DESIGN RELIABILITY ASSURANCE PROGRAM PLAN

SYSTEM 80+ STANDARD DESIGN

DECEMBER, 1992
REV. 1

ABB COMBUSTION ENGINEERING NUCLEAR POWER
WINDSOR, CONNECTICUT

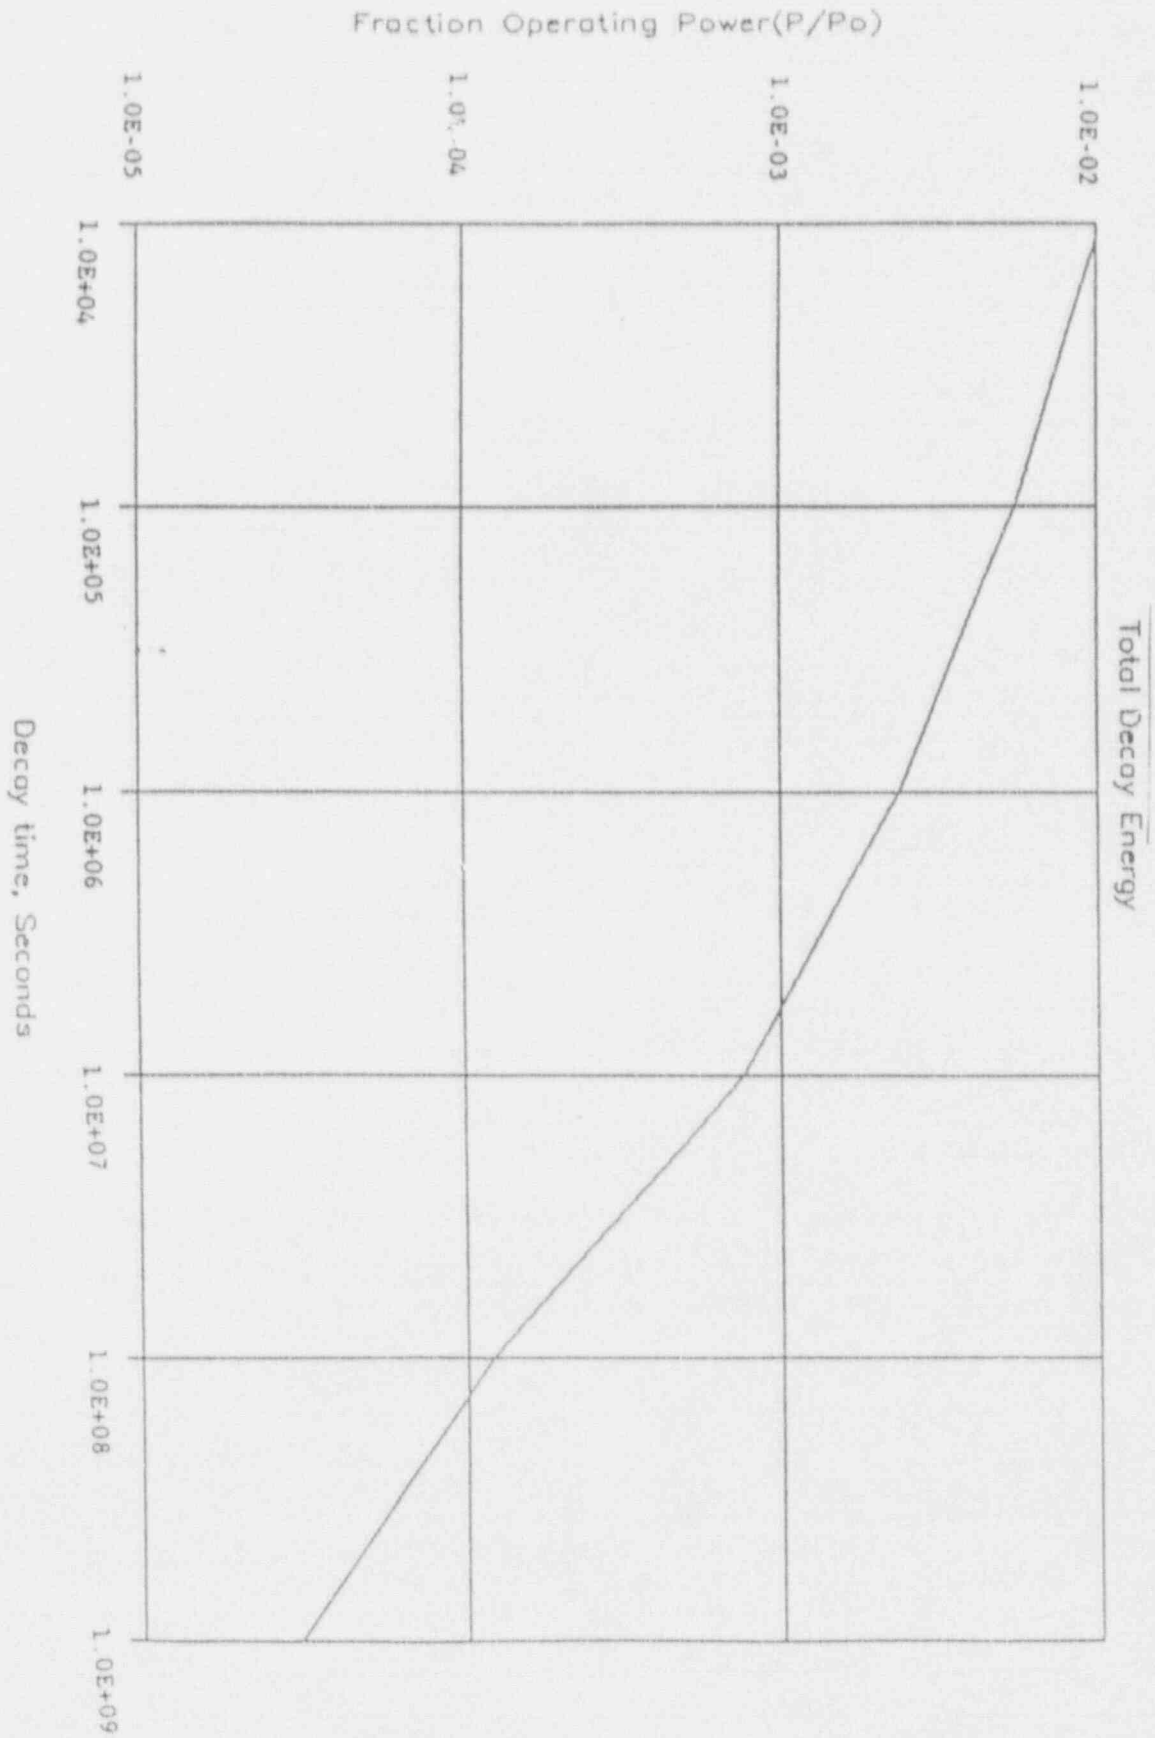
The applicants response to RAI Q410.56 regarding heat generation rate calculations is incomplete. The applicant should show how the spent fuel cooling system meets the assumed conditions given in SRP 9.1.3 Issue III H.iii and III H.iv. The applicant should incorporate the missing material into CESSAR Section 9.1.3.

Response to Open Item 9.1.3-1:

In accordance with SRP Section 9.1.3 Issue III H.iii, for abnormal conditions the spent fuel pool cooling system should have the capacity to remove the decay heat from one full core at equilibrium conditions after 150 hours decay and one refueling load at equilibrium conditions after 36 days decay without spent fuel pool bulk water boiling. Cooling system single failure need not be considered concurrent with this condition.

Based on the above requirements, a total decay heat load was calculated using the decay energy vs. time after shutdown curve provided in Attachment (1). This curve was previously submitted in response to NRC RAI Q410.56. The resultant spent fuel pool decay heat load for this condition is 52.65×10^6 Btu/Hr.

System 80+ CESSAR-DC Section 9.1.3.1.4, "System Capacity Basis", states that the System 80+ pool cooling system is designed to remove decay heat from a full core offload heat load (which is the abnormal heat load). This is equal to the normal spent fuel pool heat load, plus the addition of decay heat from a full core offload 120 hours after shutdown. The normal heat load is the decay heat which occurs when an accumulation of spent fuel equal to 10 full power years is in the spent fuel pool with the newest spent fuel batch having just been placed in the pool during refueling at 120 hours after shutdown. The resultant decay heat load calculated for this condition, using the Attachment (1) curve, is 65.27×10^6 Btu/Hr.

Section 9.1.3.1.4 also states that for the above abnormal spent fuel loading condition concurrent with normal plant operation (which is both cooling trains operating, (no single failure)) the spent fuel pool maximum bulk water temperature is 140°F.

Based on the above information, the System 80+ design meets the criteria in SRP 9.1.3 since the System 80+ cooling system is designed to remove a spent fuel pool heat load of 65.27×10^6 Btu/Hr, which is greater than the 52.65×10^6 Btu/Hr required by SRP 9.1.3. Also the System 80+ design must keep the spent fuel pool bulk water temperature $\leq 140^\circ\text{F}$, where in SRP 9.1.3 the pool must not bulk boil.
